To: T10 Technical Committee
From: Bob Sheffield(robert.l.sheffield@intel.com)
Date: 22 May 2006
Subject: 06-216r1: SAT - Block Mapping Issues

SAT-r08 - SCSI / ATA Translation revision 08

Figure 8 — REASSIGN BLOCKS command translation

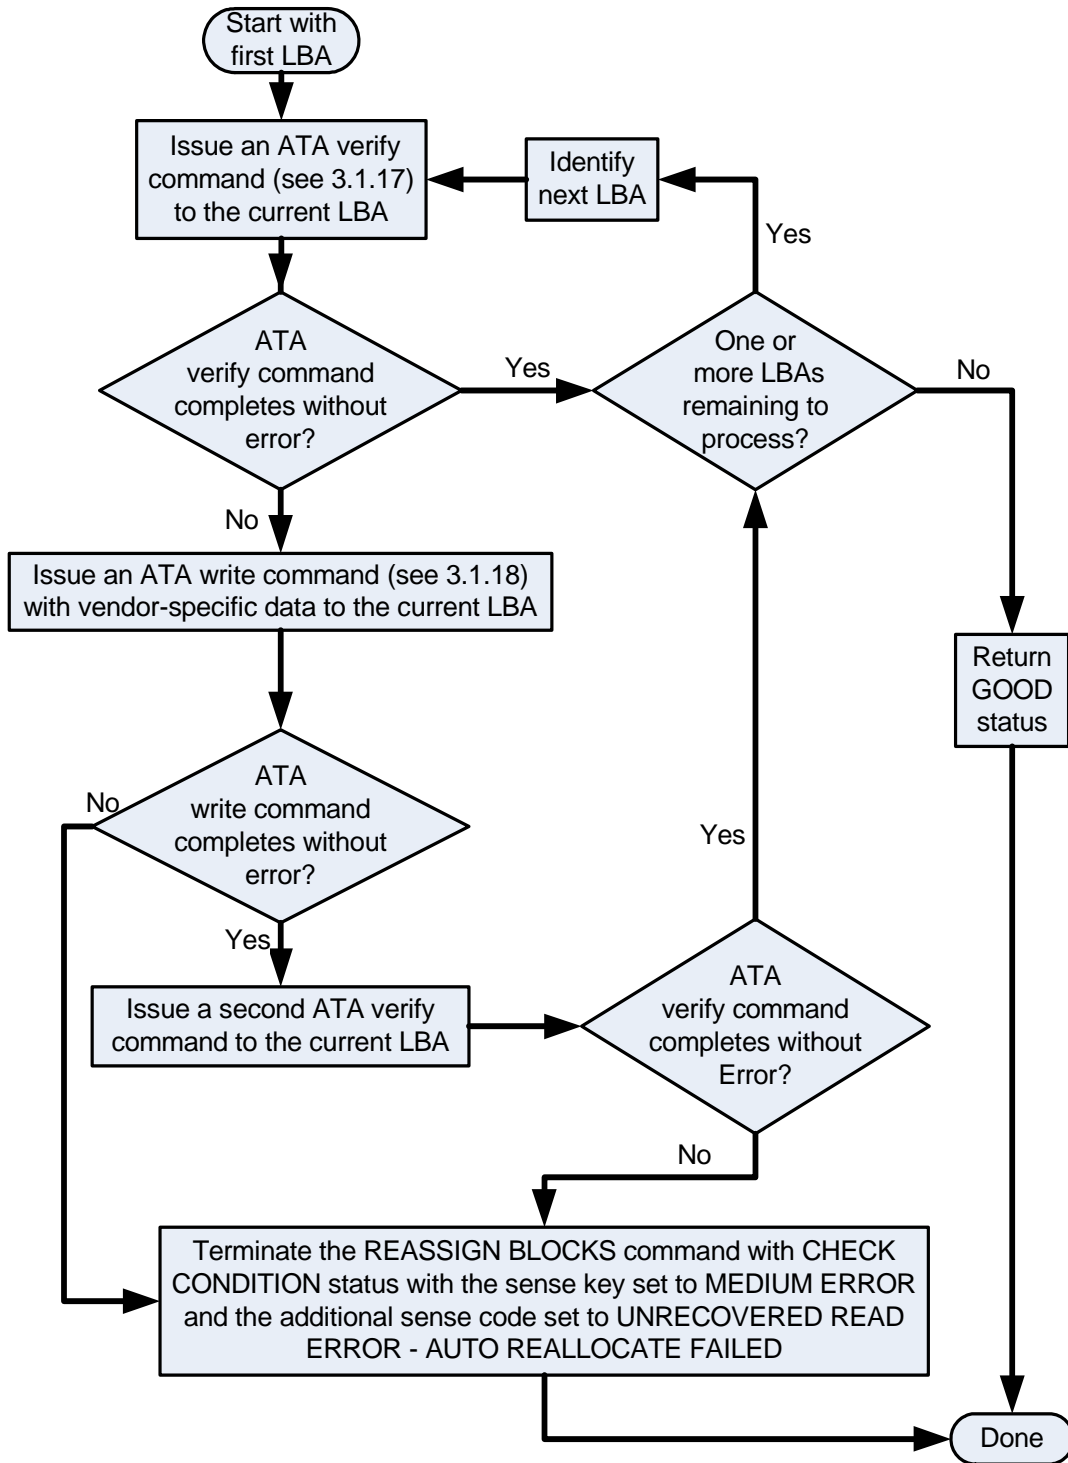
- ~~1) issue an ATA verify command (see 3.1.17) to the specified LBA;~~
- ~~2) if the ATA verify command completes successfully, then the SATL shall return GOOD status for the REASSIGN BLOCKS command;~~

- ~~3) if the ATA verify command does not complete successfully, then the SATL shall issue an ATA write command (see 3.1.18) with vendor specific data to the LBA that failed the ATA verify command;~~

- ~~5) if the write command completes successfully, then the SATL shall issue a second ATA verify command to the same LBA;~~
- ~~6) if the second ATA verify command completes successfully, then the SATL shall return GOOD status for the REASSIGN BLOCKS command; and~~

~~if the second ATA verify command does not complete successfully, then the SATL shall terminate the REASSIGN BLOCKS command with CHECK CONDITION status with the sense key set to MEDIUM ERROR and the additional sense code set to UNRECOVERED READ ERROR — AUTO REALLOCATE FAILED.~~

The SATL shall process each ATA LBA corresponding to LBAs specified in the parameter list as shown in figure 8.

The REASSIGN BLOCKS command parameter list ~~provided in the data-out buffer transferred from the application client~~ contains the LBAs of logical blocks to be reassigned. The LBAs provided in the parameter list shall be utilized for the ATA LBAs in any ATA verify commands (see 3.1.17) or ATA write commands (see 3.1.18) issued by the SATL.

If the SATL implements direct block mapping (see 9.1.2), then the values set by the SATL in the ATA LBA of the ATA verify command(s) and ATA write command(s) shall equal the value(s) of the LBAs in the parameter list. Otherwise, the mapping is unspecified (see 3.4.3).
